**TO:** City Plan Board **Item Number:** 2  
**FROM:** Planning & Development Services **DATE:** May 26, 2016  
**Department Staff**  
**SUBJECT:** Petition PB-16-39 SUP. eda engineers-surveyors-planners, inc., agent for Prairie View Trust, owner. Special use permit with major development plan review to allow the construction of a hotel. Zoned MU-1 (8-30 units/acre mixed use low intensity). Located at 3989 SW 37<sup>th</sup> Boulevard.

# FAIRFIELD INN & SUITES HOTEL

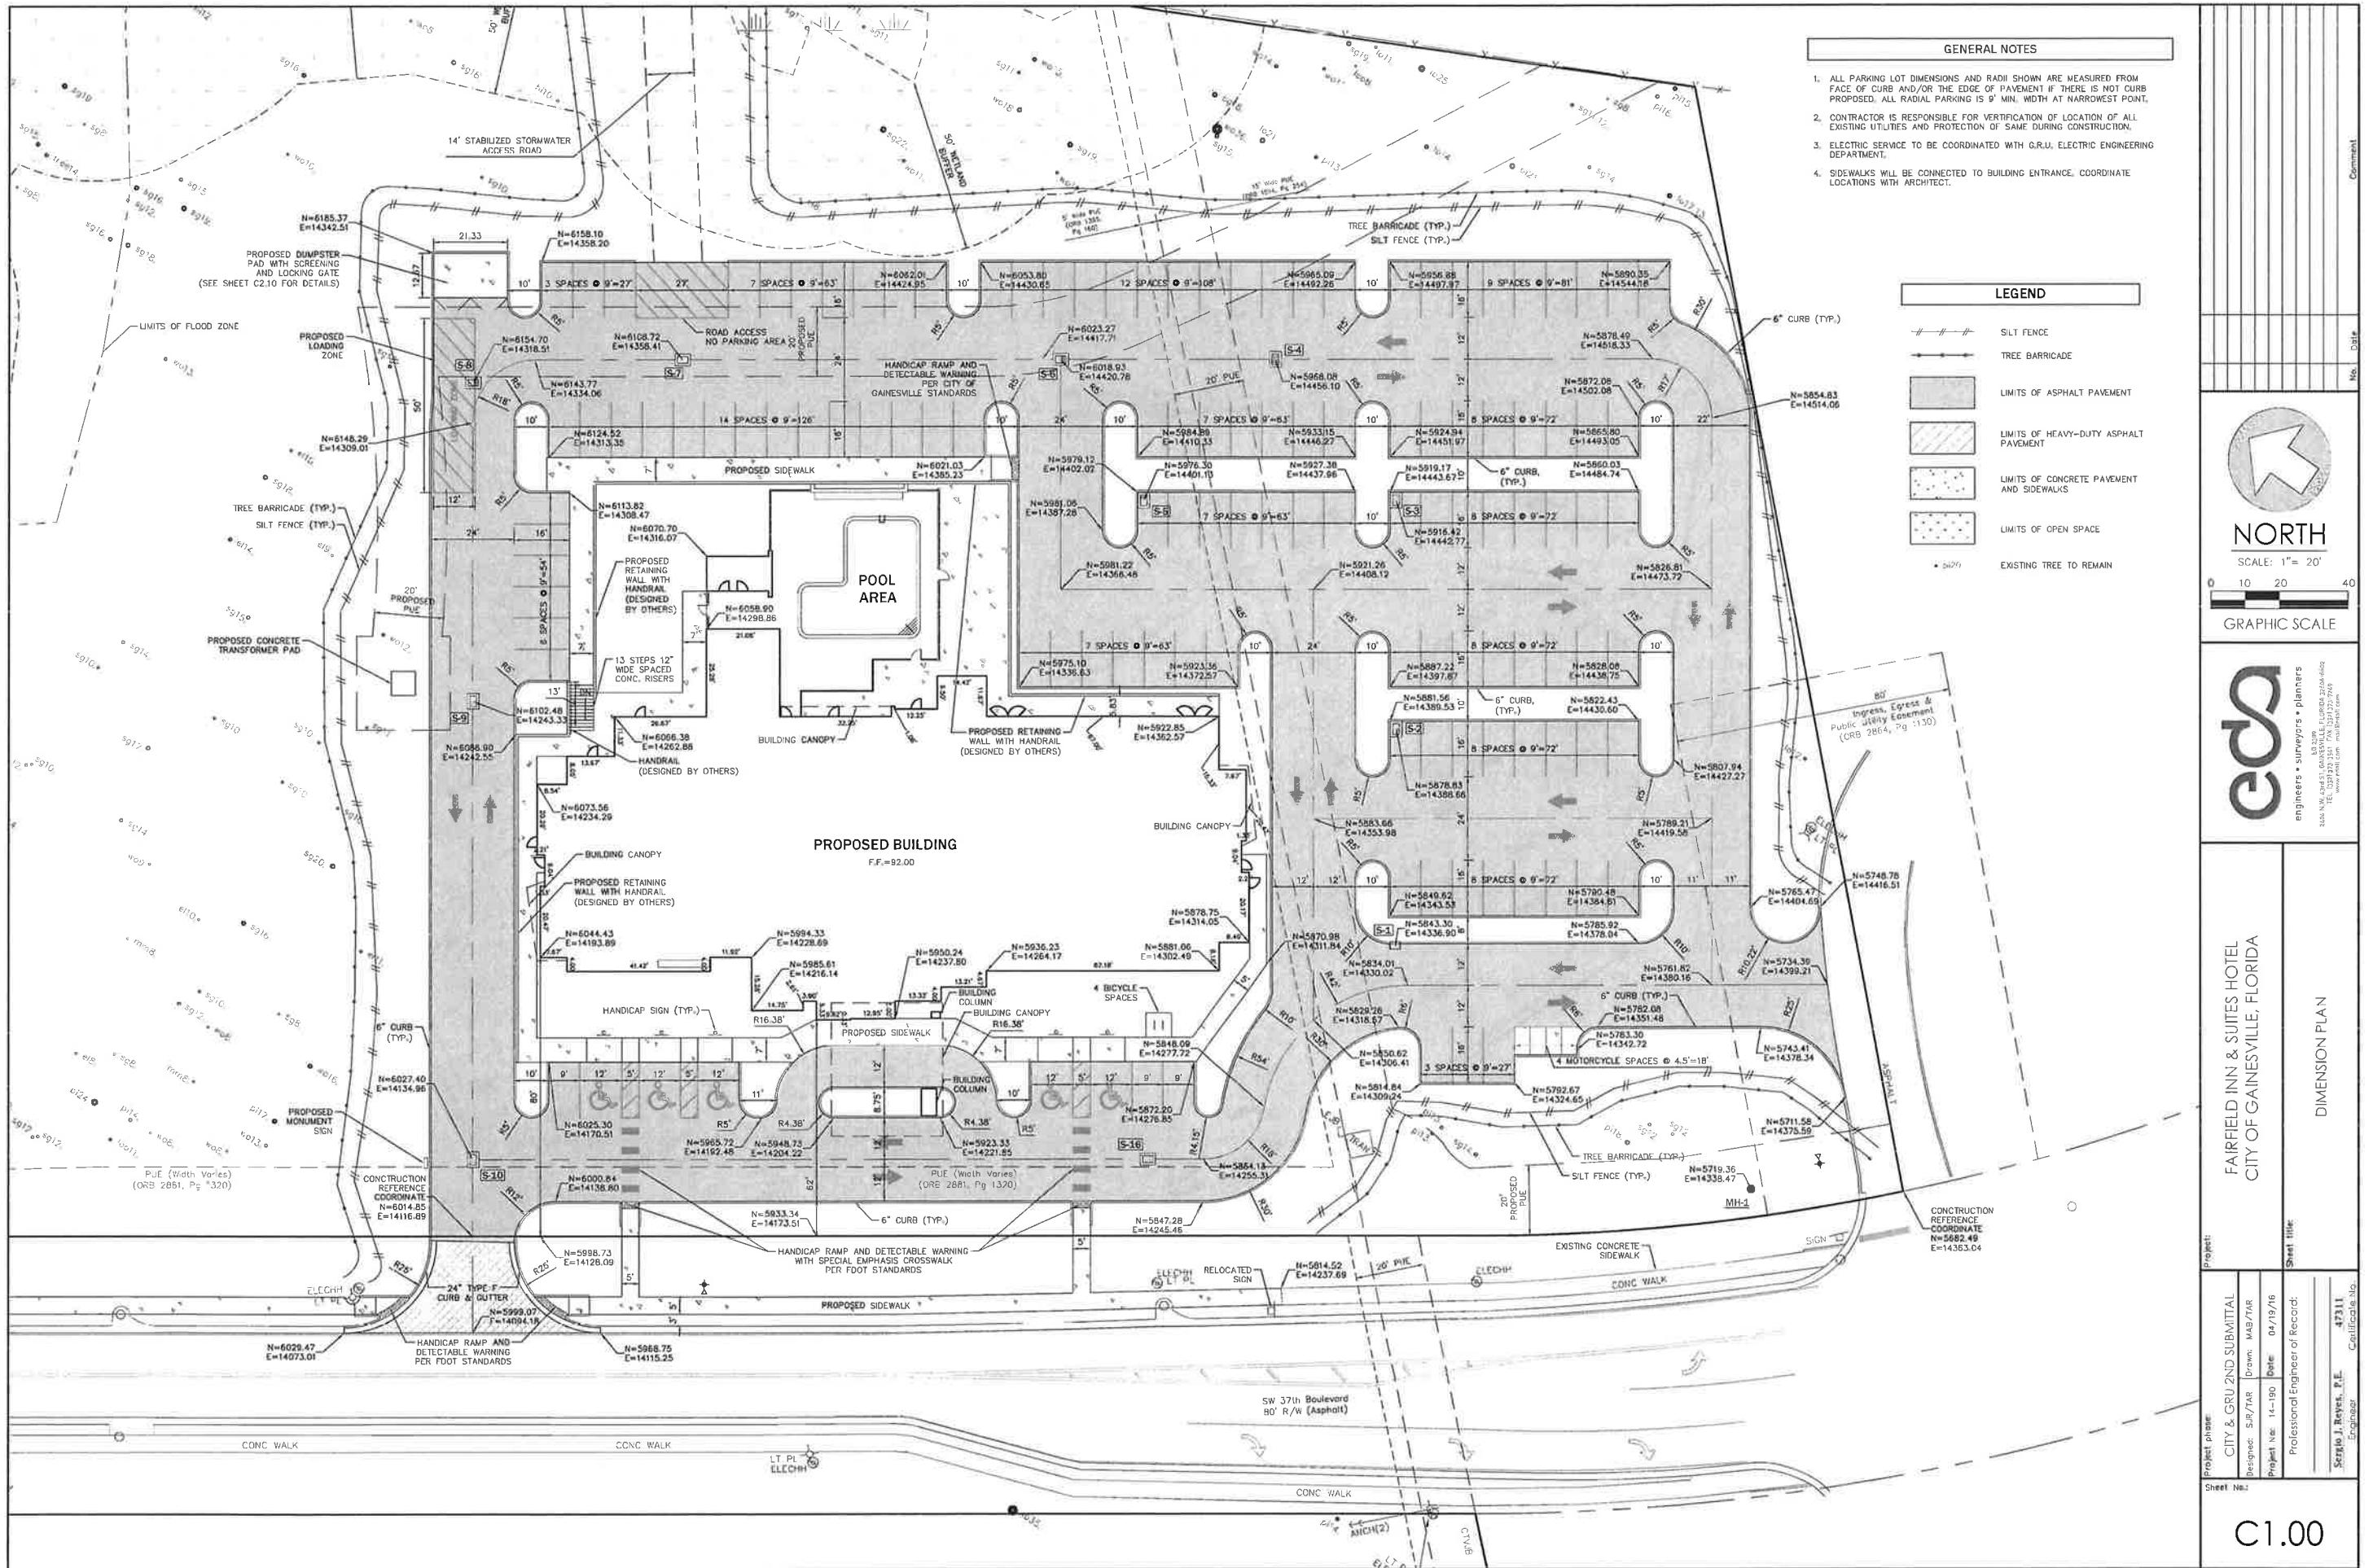
6. Sheet C1.00 must be corrected. The number of spaces shown between the striped area representing the stormwater access road and the landscape island immediately south is 7.

CANOPY LIGHTING DETAIL

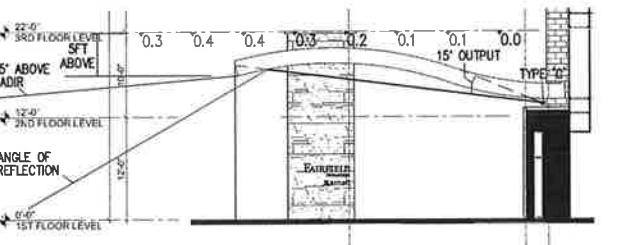
12. The applicant must obtain a board-approved waiver to use non cut-off light fixtures beneath the main entry canopy. **If indirect lighting is proposed, the applicant must show in the detail on Sheet E-2 compliance with Sec. 30-344 (e) (6) c, which requires all direct illumination to be focused exclusively on the underside of the canopy.**

1. LIGHTING IN THE MAIN ENTRY CANOPY AREA IS PROVIDED BY INDIRECT MEANS AS PERMITTED BY 30-344(e)(6)(c). LIGHT LEVELS AT 5FT ABOVE CANOPY COMPLY WITH THIS SECTION. SEE CANOPY LIGHTING DETAIL, THIS SHEET.
2. WITH THE EXCEPTION OF THE MAIN ENTRY CANOPY, ALL PROPOSED LIGHTING IS FULL CUT-OFF. THEREFORE, LIGHT LEVELS AT 5FT ABOVE THE FIXTURE ARE 0 FC BY DEFINITION.
